CITY OF LOS ANGELES

6501 South Sepulveda Boulevard DOT Case No. CTC21-111067 (51293)

Subject: TRANSPORTATION ASSESSMENT FOR THE PROPOSED SEPULVEDA/CENTINELA MIXED-

USED PROJECT LOCATED AT 6501-6521 S. SEPULVEDA BLVD AND 6502-6520 S. ARIZONA AVENUE (ENV-2021-4938-EAF/CPC-2021-4937-CU-DB-SPR-WDI-HCA)

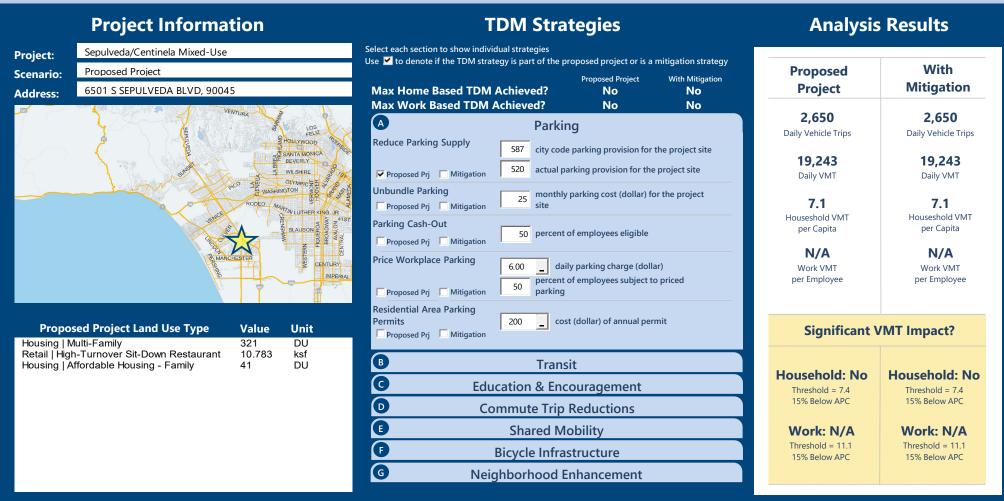
Project Screening Criteria: Is this project required to conduct a vehicle miles traveled analysis?

| Existing Land Use | Proposed Project | | | | | | | | |
|--|--------------------------|--------------------------|--|--|--|--|--|--|--|
| The proposed project is required to perform VMT analysis. | | | | | | | | | |
